## FUN KART NOT REACHING TOP SPEED

TSB170

DATE: 29 June 2016

fig. 3

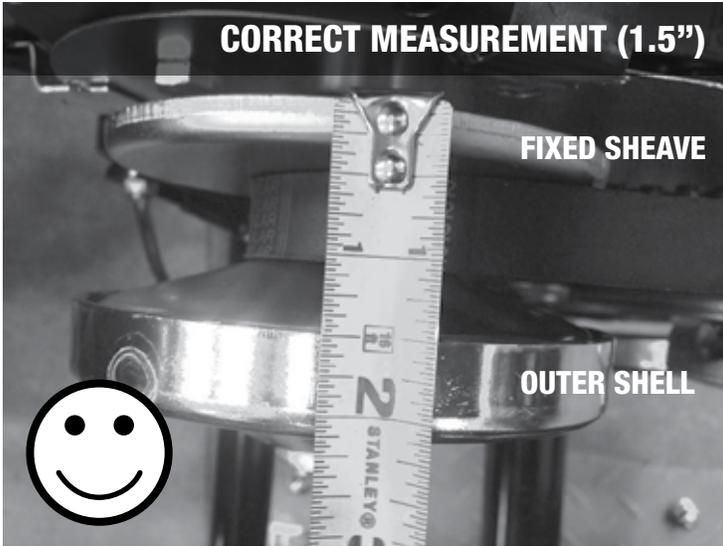
- 2 MEASUREMENTS**  
Using a Tape Measure, measure the distance on the driver pulley from the fixed sheave to the edge of the outer shell. Ref figure 2.
  - Fig 3 – IF the distance measures 1 5/8", the speed reduction spacer will need to be removed. Go to step 3.
  - Fig 4 – IF the distance measures 1 1/2", the pulley is set to the proper specification. Re-install the belt guard cover. No further action required.

- 3 SPEED REDUCTION SPACER REMOVAL**  
If the Driver Pulley measures 1 5/8" per step 2, the speed reduction spacer will need to be removed to restore the proper top speed on the unit. To remove the spacer:

fig. 5 Driver Pulley Assembly

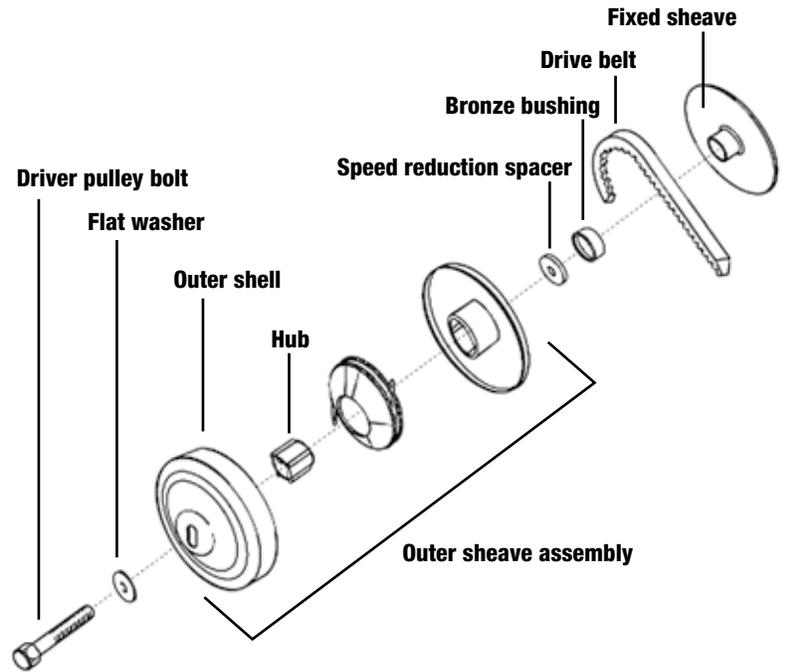
4. Remove the Speed Reduction Spacer and re-assemble the outer sheave assembly in the order as shown in Fig 5.
  5. Install the Driver Pulley Bolt and Flat Washer by turning clockwise into the crankshaft. To tighten, firmly pull the engine pull rope out of the recoil (approx. 6") and snug Driver Pulley Bolt until tightened.

fig. 6

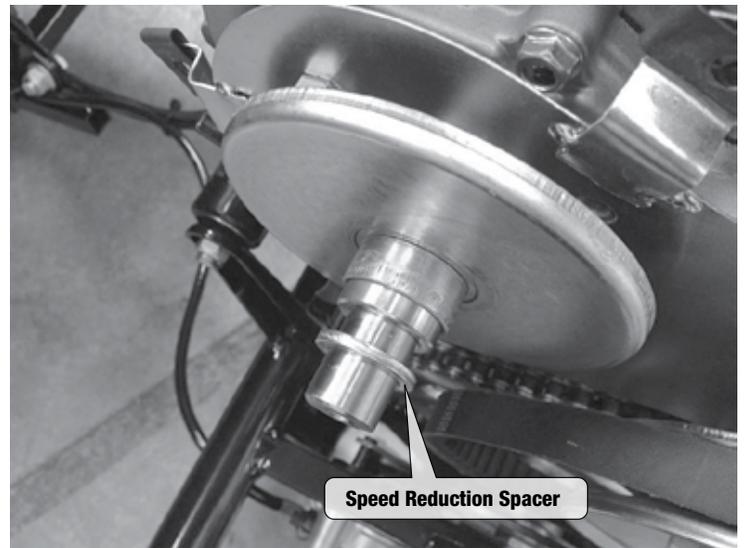
2. Remove the outer sheave as an assembly exposing the belt and fixed sheave.
  3. With the outer sheave assembly removed, the Speed Reduction Spacer will be exposed. Ref Fig 6.
